**AGENDA**  
**MANOR PLANNING AND ZONING COMMISSION**  
**105 E. EGGLESTON ST.**  
**MANOR, TEXAS 78653**  
**AUGUST 12, 2015, 6:30 P.M.**

Re: First Construction Plan and Final Plat Review for  
Shadowglen Phase 2, Section 20 Subdivision  
City of Manor, Texas

Re: Stonewater Subdivision Phase 5  
First Final Plat Application Submittal  
City of Manor

Re: Stonewater Subdivision Phase 7  
First Final Plat Application Submittal  
City of Manor

Re: Comment Response to David Smith's [Jay Engineering]  
First Final Plat Review for Stonewater Subdivision Phase 5 to the City of Manor, Texas -  
May 21, 2015.

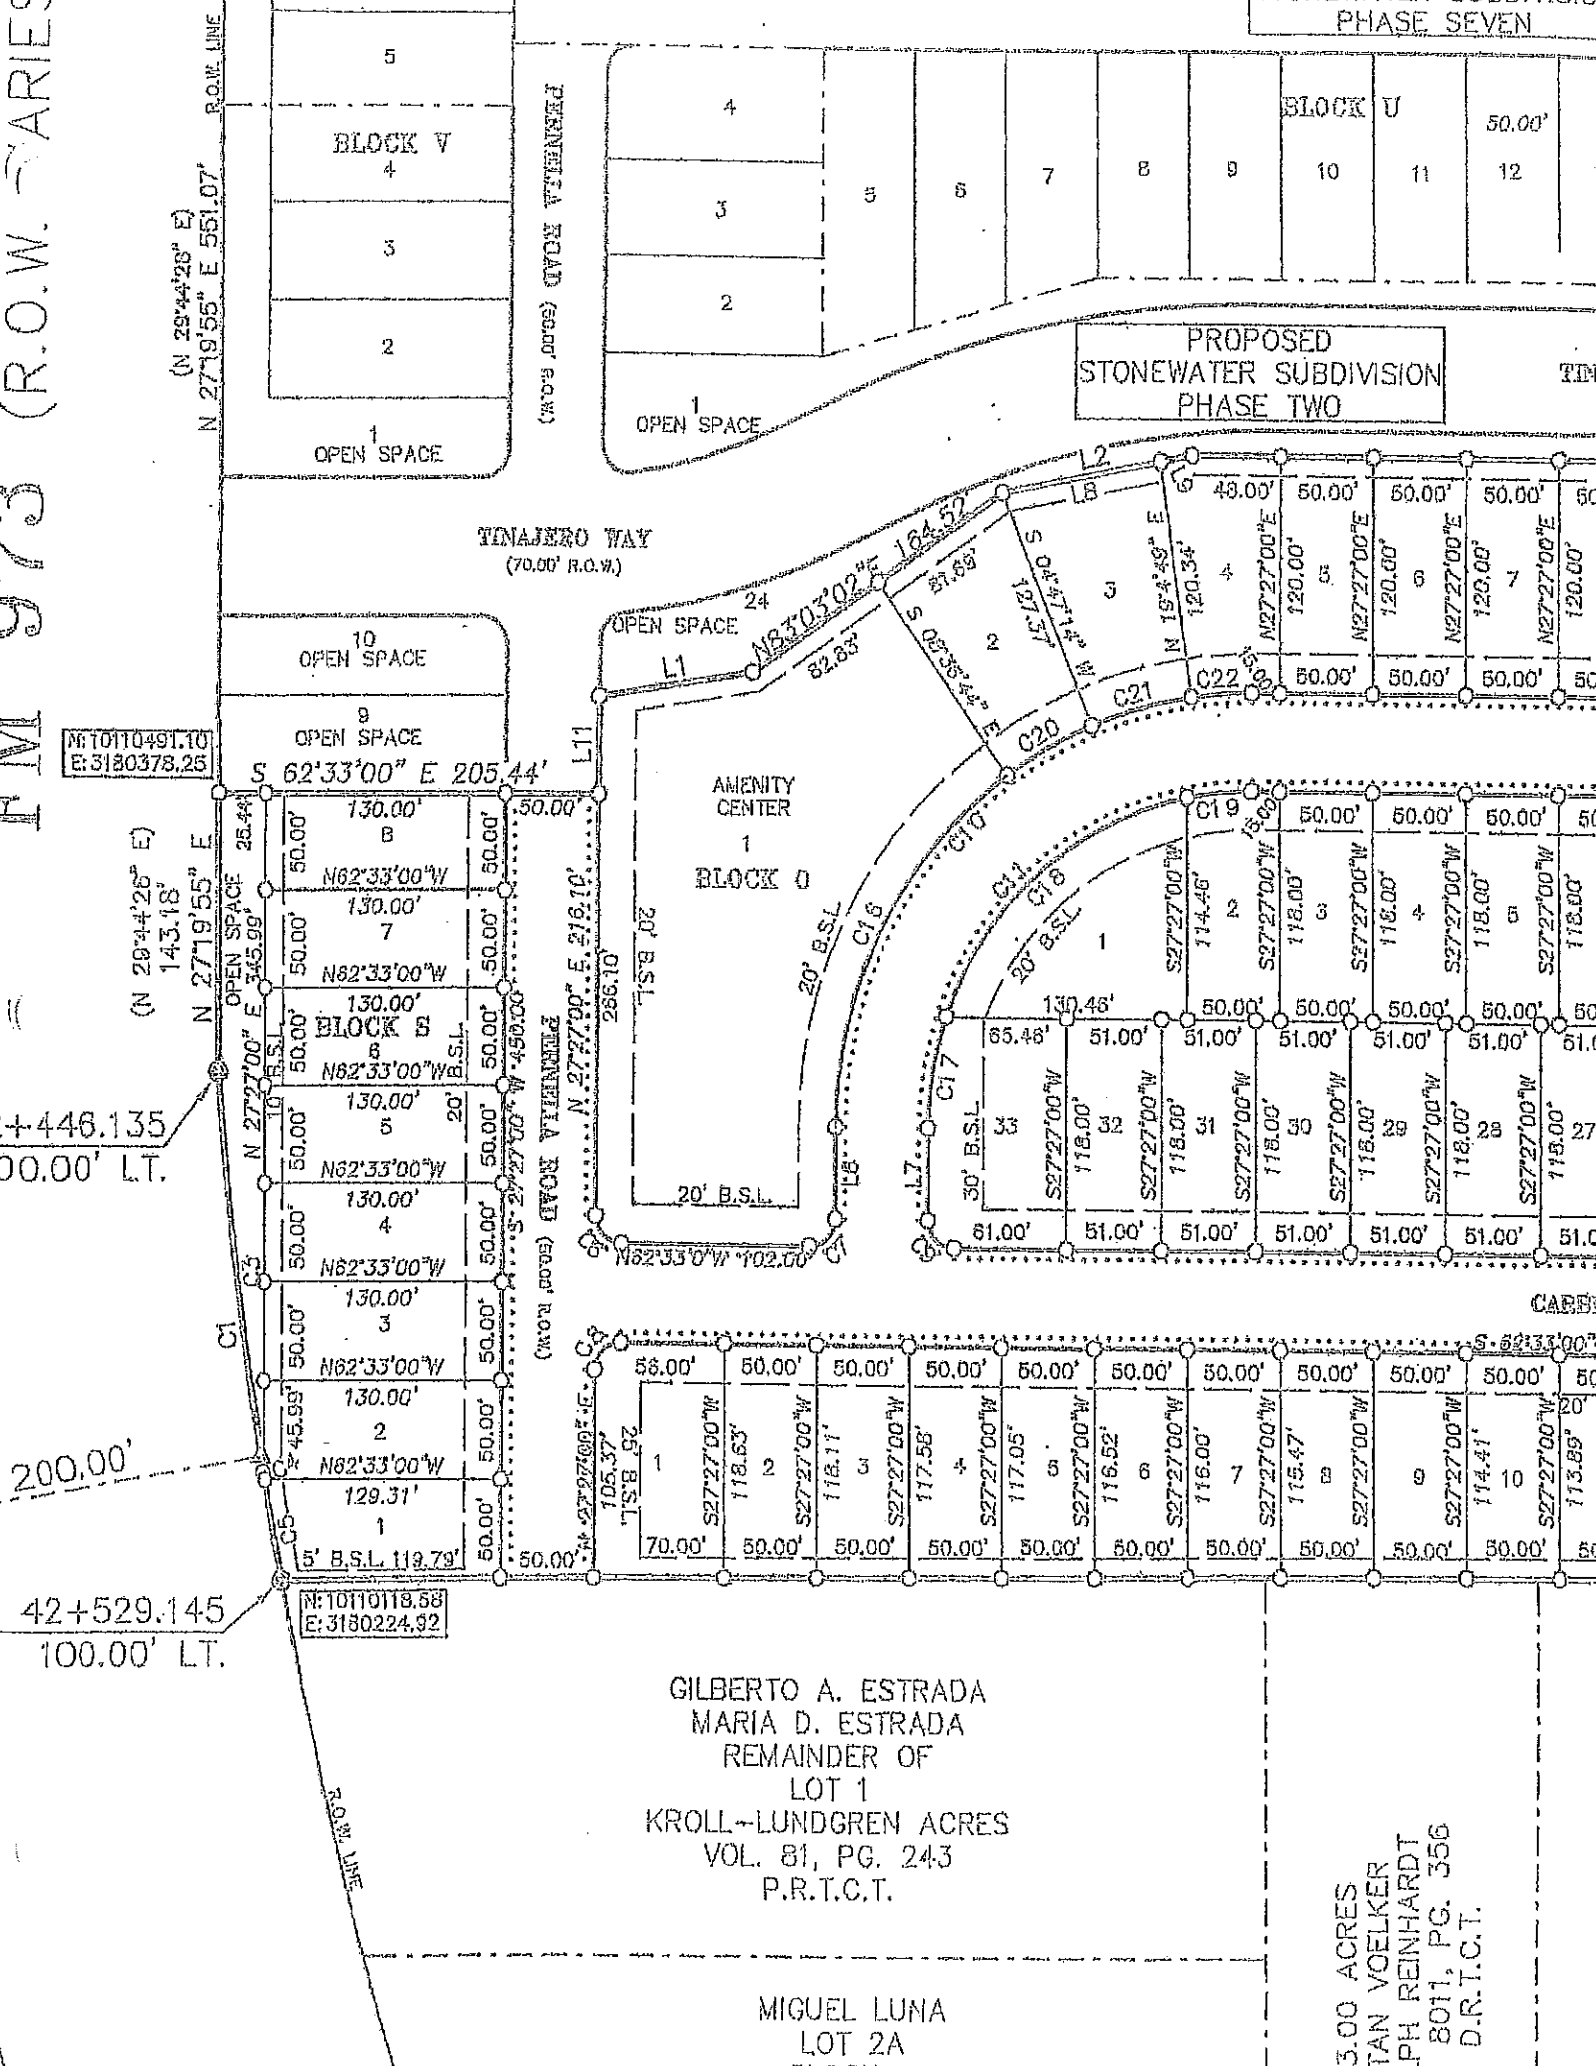
1. Plat does not contain the addresses of the owner of record as required by Section 24(c)(1)(ii) of Subdivision Ordinance 263 B. The date, scale, north point, addresses of the owner of record, developer, registered public surveyor, and registered professional engineer if required, platting the tract must be shown on the plat.

2. The ownership of parcel 248058 needs to [be] verified as required in Section 24 (c)(1)(v) of Subdivision Ordinance 263 B. The owner's names and property lines of property within three hundred (300) feet of the subdivision boundary, together with the respective plat of deed references as determined by the most recent tax rolls must be shown on the plat.

3. Proof of fee payment to Manville Water Supply Corporation must be provided as required in Section 24(c)(1)(viii) of Subdivision Ordinance 263 B.

4. Proof of new street name approval by Travis County 911 addressing was not submitted as required in Section 24(c)(1)(xi) of Subdivision Ordinance 263B. Where new streets are being created and named, the applicant must have documentation from Travis County 911 Addressing demonstrating that the street names proposed on the Final plat are not duplicated within the County.

5. Plat does not include the city limits line as required in Section 24(c)(2)(iv) of Subdivision Ordinance 263 B. Location of City limit lines and/or outer border of the City's extra-territorial jurisdiction, as depicted on the City's most recent base map, if either such line traverses the subdivision or is contiguous to the subdivision boundary must be shown on the plat.

6. The open space lot along FM973 is not numbered as required in Section 24(c)(4)(iv) of Subdivision 263 B. The property lines and number designations of all proposed lots and blocks, with complete bearings, distances and dimensions for front, rear and side lot lines must be shown on the plat.

***Response: The plat has been updated to include the address of the owner of record on sheet 01.***

***Response: Parcel 248058 is not within the 300 feet of the Founders Ridge boundary thus not required to be documented on the plat.***

***Response: Payment to Manville Water Supply Corporation has been submitted and awaiting on feasibility study by MWSC engineer.***

***Response: Email correspondence showing proof of new street name approved by Travis County 911 addressing has been included with this submittal.***

***Response: Plat now includes the City of Manor ETJ line as shown on sheet 02.***

***Response: The open space lot along FM973 has been numbered to 11 on Block 5 as shown on sheet 02.***

Re: Comment Response to David Smith's [Jay Engineering]  
First Final Plat Review for Stonewater Subdivision Phase 7 to the City of Manor, Texas -  
May 21, 2015.

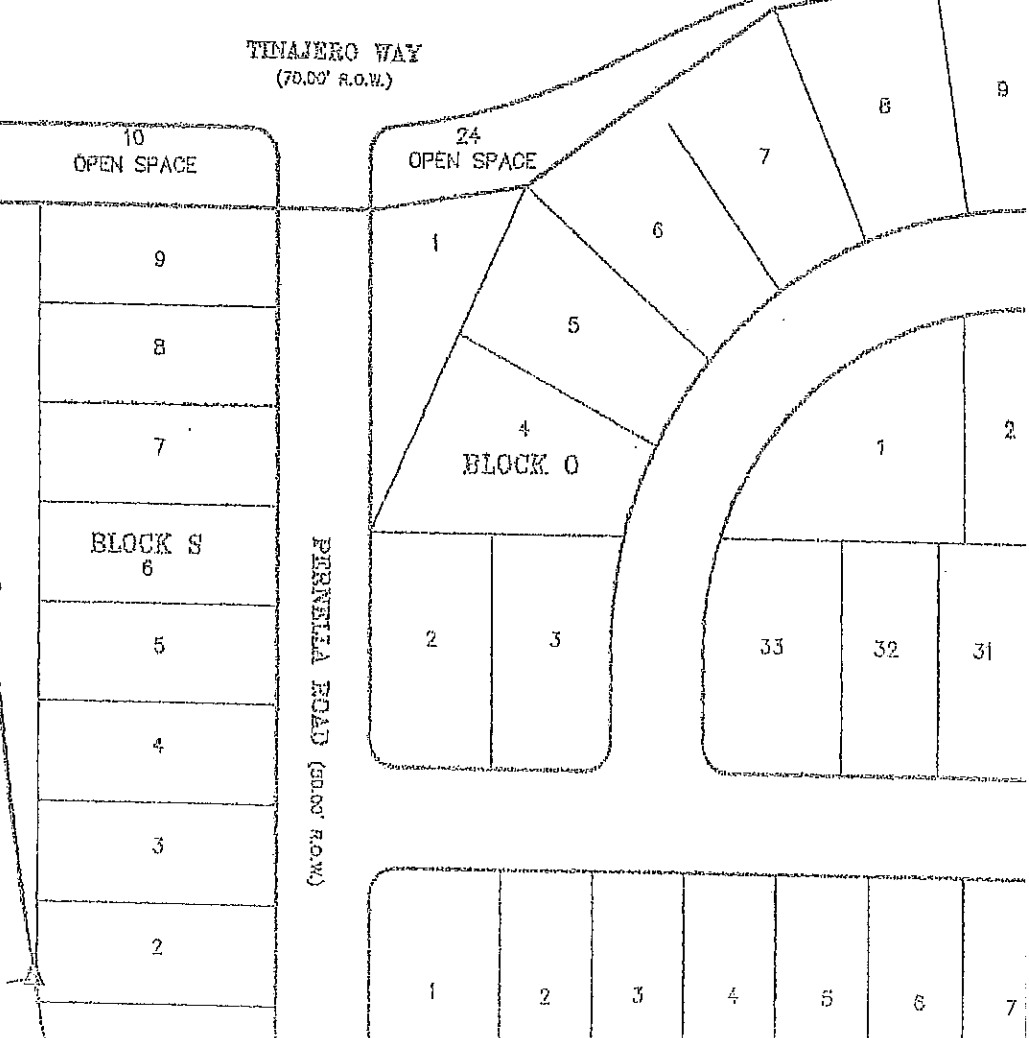
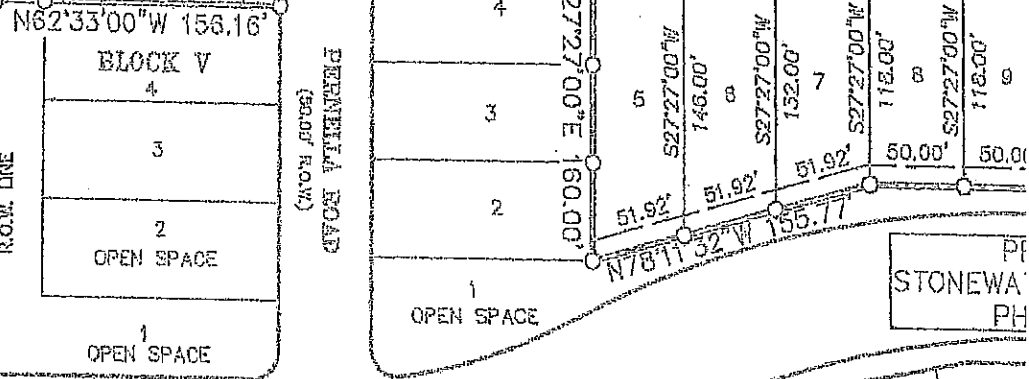
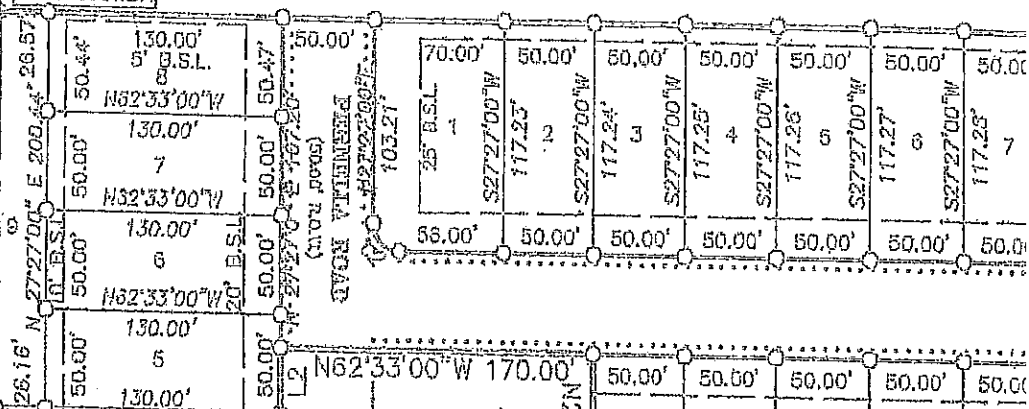
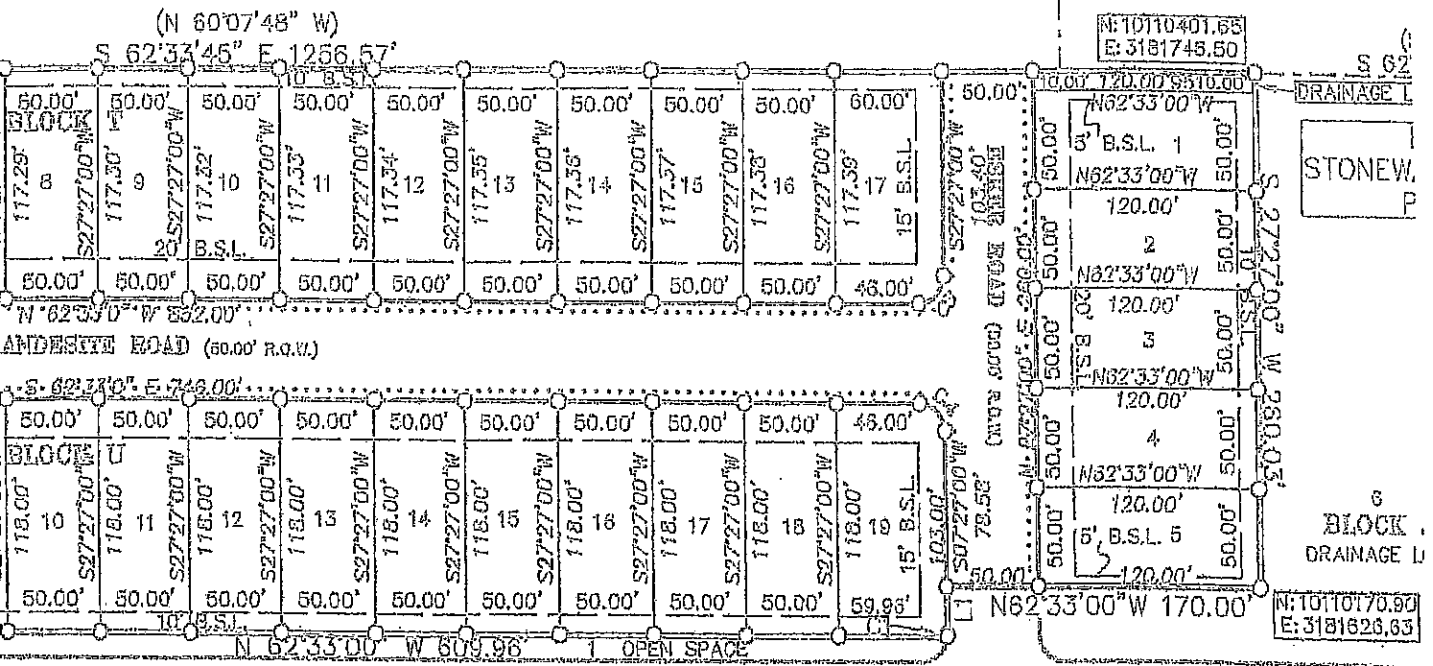
1. Plat does not contain the addresses of the owner of record as required by Section 24(c)(1)(ii) of Subdivision Ordinance 263 B. The date, scale, north point, addresses of the owner of record, developer, registered public surveyor, and registered professional engineer if required, platting the tract must be shown on the plat.

5. Plat does not include the city limits line as required in Section 24(c)(2)(iv) of Subdivision Ordinance 263 B. Location of City limit lines and/or outer border of the City's extra-territorial jurisdiction, as depicted on the City's most recent base map, if either such line traverses the subdivision or is contiguous to the subdivision boundary must be shown on the plat.

6. The drainage lot on Esker Road is not numbered as required by Section 24(c)(4)(iv) of Subdivision Ordinance 263 B. The property lines and number designations of all proposed lots and blocks, with complete bearings, distances and dimensions for front, rear and side lot lines must be shown on the plat.

7. The open space lot within the block is not designated and numbered as required by Section 24(c)(4)(iv) of Subdivision 263 B. The property lines and number designations of all proposed lots and blocks, with complete bearings, distances and dimensions for front, rear and side lot lines must be shown on the plat.

***Response: The plat has been updated to include the address of the owner of record on sheet 01.***

***Response: Plat now includes the City of Manor ETJ line as shown on sheet 02.***

***Response: The drainage lot on Esker Road has been numbered 6 in Block J as shown on sheet 02.***

***Response: The open space lot within the block has been numbered to 9 of Block V as shown on sheet 02.***
